**Before the Independent Hearings Panel  
At Wellington City Council**

**In the matter of** Hearing submissions and further submissions on the  
Proposed Wellington City District Plan

**Statement of supplementary planning evidence of Andrew Wharton on  
behalf of Wellington City Council**

**Date: 14 February 2023**

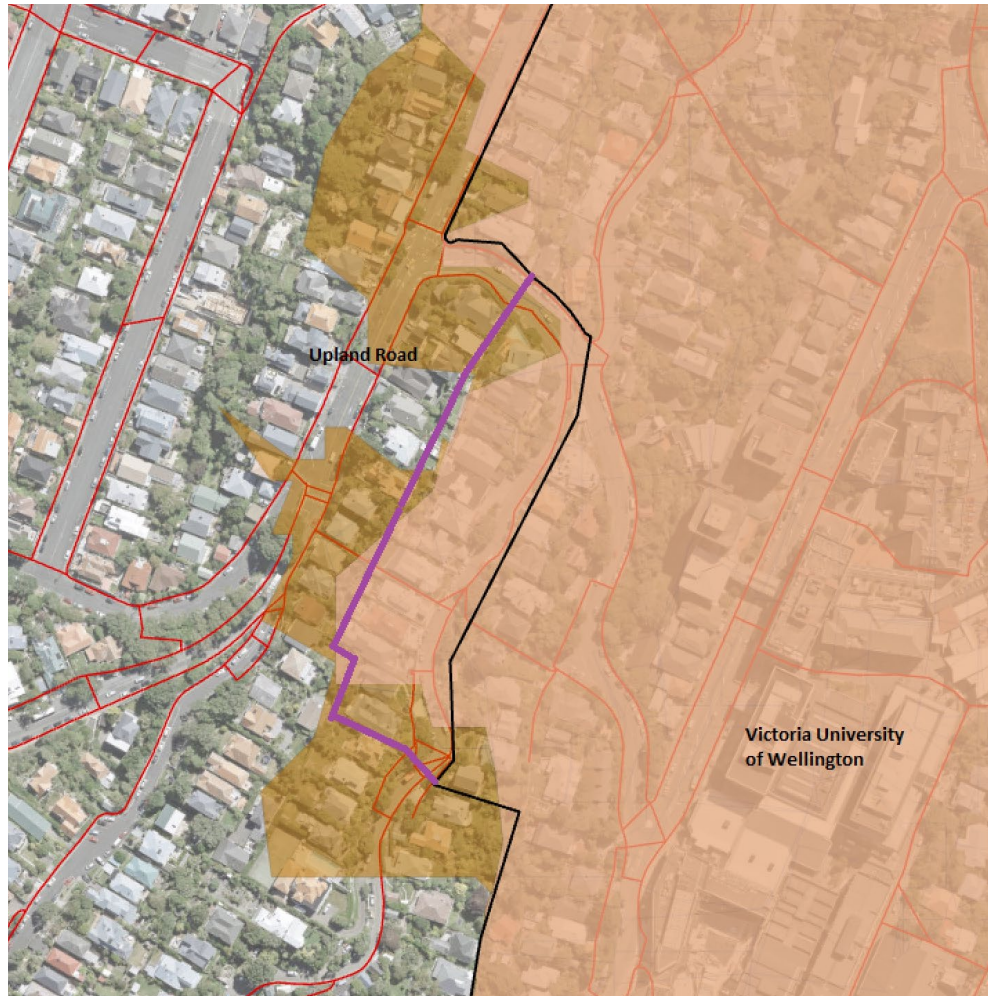
- 38     **HDRZ in Kelburn:** Mr Rae recommends (paras 9.15 – 9.19, 10.15) that the High Density Residential Zone in Kelburn should respond consistently to landform by including the land between Victoria University of Wellington and the western hill ridge behind the University, including the southern part of Upland Road and Grove Road.

- 39     I have reviewed the CCZ 15 minute walkable catchment modelling results and walkable routes, and agree in part with Mr Rae, that the properties 2–26 Central Terrace, Kelburn should be included in the High Density Residential Zone. These houses are within the 15 minute CCZ walkable catchment (median of 'towards' and 'away' times) as shown below, and continue the CCZ to the ridgeline above Victoria University.

- 40     I do not support further extending the HDRZ along all of Central Terrace, as this is outside the 15 minute walkable catchment in my S42A Report recommendation.

- a. HS1-Rec11: In Figure 37 of the Stream 1 S42A Report, extend the HDRZ (15 minute catchment) to include the properties 2–26 Central Terrace, Kelburn.
- b. HS1-Rec12: Replace the term “Walking catchment” with “Walkable catchment”.
